elm creek Watershed Management Commission

AGENDA

August 10, 2016

Grading Plan

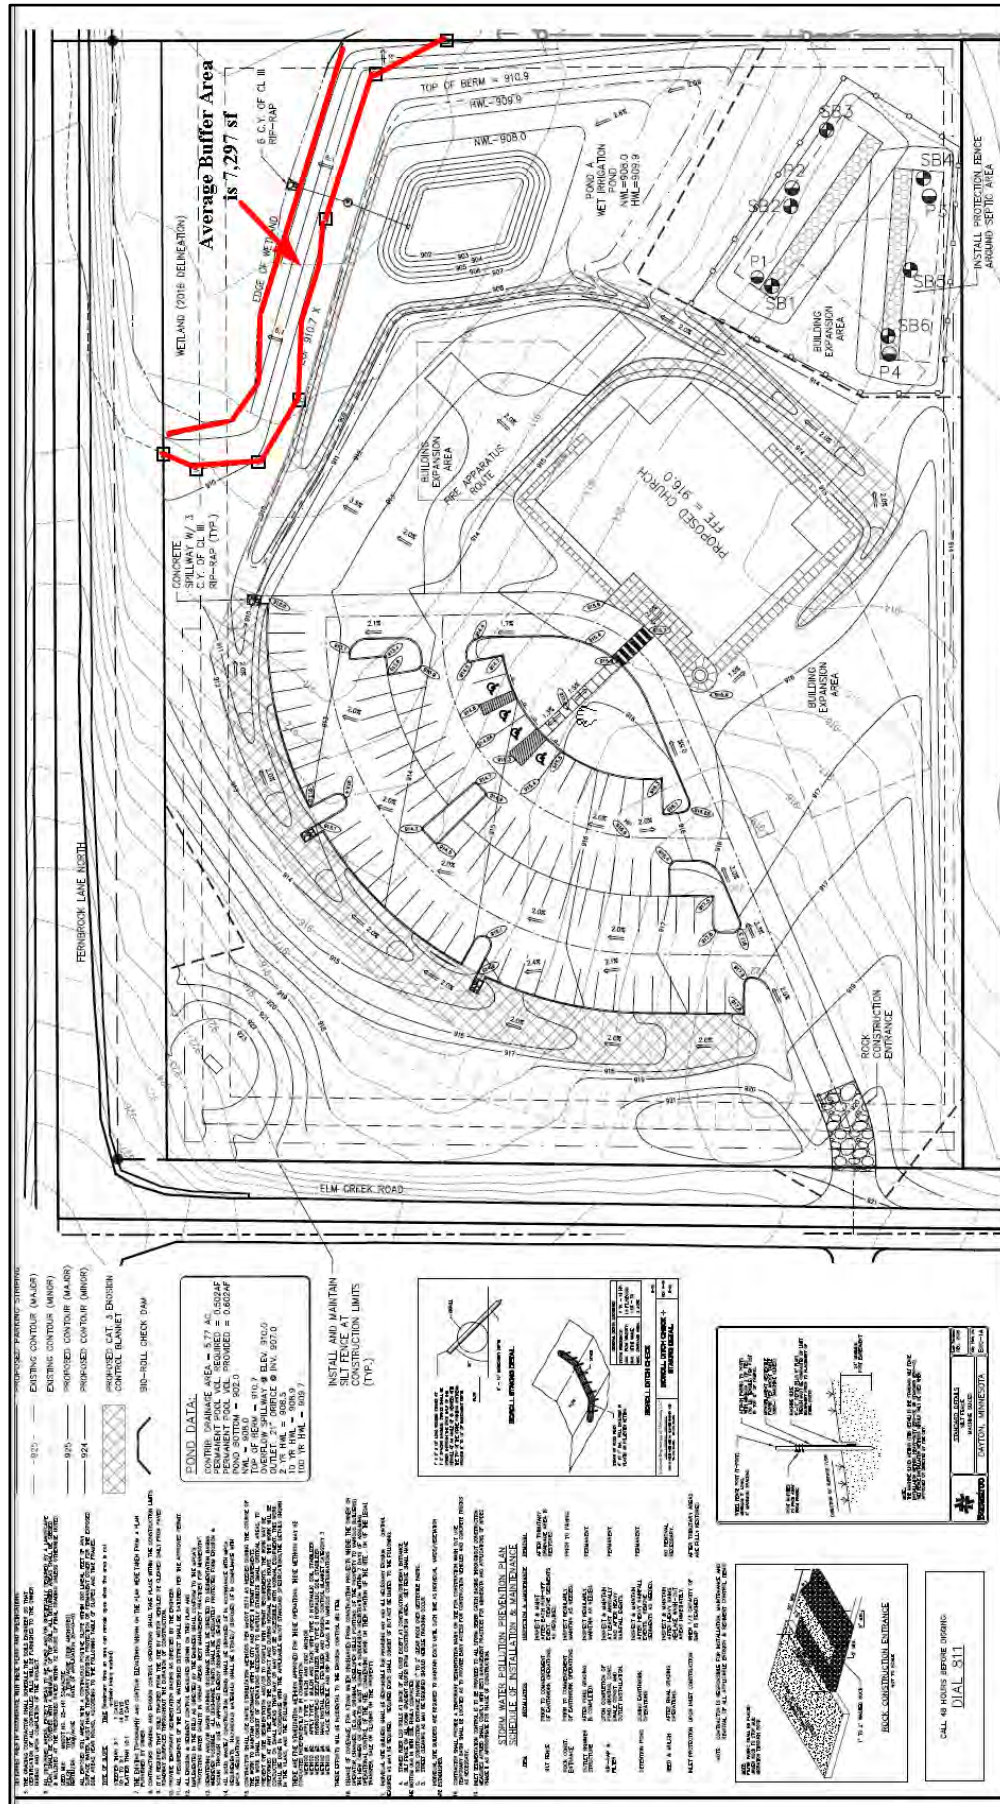
- 1) A complete application was received on June 2, 2016. The initial 60-day review period expires August 1, 2016. Due to plan revisions necessary to comply with Commission's standards. The decision period was extended an additional 45 days to September 15, 2016.
- 2) The site will disturb 5.40 acres out of total area of 12.2 acres. The remaining 6.80 acres will be platted as an outlot. Per ECWMC Rules and Standards for a commercial/industrial redevelopment site that disturbs more than one acre but less than 50 percent of the site must meet the following standards for the disturbed area, including the impervious area within the disturbed area:
 - a. Rate control
 - b. Volume management
 - c. Erosion and sediment control
 - d. Water quality
 - e. Buffer strips

- 1) Volume Control: The proposed plan will create a total of 1.34 acres of new impervious surface. This requires about 5,350 cubic feet of volume abstraction. Therefore, the applicant is proposing to achieve the required water quantity and quality controls by constructing wet irrigation pond of a surface area 10,915 sf.
 - a. Irrigation water reuse on 2 acres of open space.
 - b. Credit reuses as calculated using RWMWD model will be for 2 acres which will obtain 54,121 cubic feet abstraction credit.
- 2) Rate Control: Applicant used the Atlas 14 precipitation distributions for stormwater hydrology, in compliance with the new Rules. The pre- and post-development flow rates leaving the site for the 24-hour duration events are shown in the following table. Rate control satisfies the Commission's standards.

- 5 Nutrient Control: A summary of the nutrient analysis for pre-development (baseline), post-development (without BMPs) and post-development (with BMP) conditions are shown below. The pre-development phosphorus load was estimated to be 12.18 lbs/yr. The post-development phosphorus loads is calculated to be 3.73 lbs from MIDs spreadsheet. The existing TSS is 936 lbs/yr and the proposed TSS is reduced to 565 lbs /yr. The nutrient and TSS control plan satisfies the Commission's standards.
- 6 Floodplains: There are no established FEMA or ECWMC flood plains within the project area.

- 7 Erosion and Sediment Control: Erosion and Sediment Control will meet the Commission's requirements. Storm Water Pollution Prevention Plan (SWPPP) narratives and site plan address NPDES and minimum Commission requirements.
- 8 Buffers: The proposed project provides an average of 25 feet of buffer (minimum 10-ft) around all the wetlands. There are three wetlands in this site located on the north, east and south. The wetlands boundary was delineated by Anderson Engineering of Minnesota, LLC in May, 2016 and shown on the plan set. The required average buffer areas for wetlands are 7,297 sf on the north side wetland, 5,235 on the east and 16,679 sf on the south sides. The proposed buffer layout satisfies the Commission's requirements.

Staff recommends the approval of the submitted plans with the following recommendation:

1. If the pond will be maintained by the property owner, an operation and maintenance plan must be submitted to the city and the watershed for review and approval. The approved O&M plan must be recorded with the property within 90 days following the final plat approval.
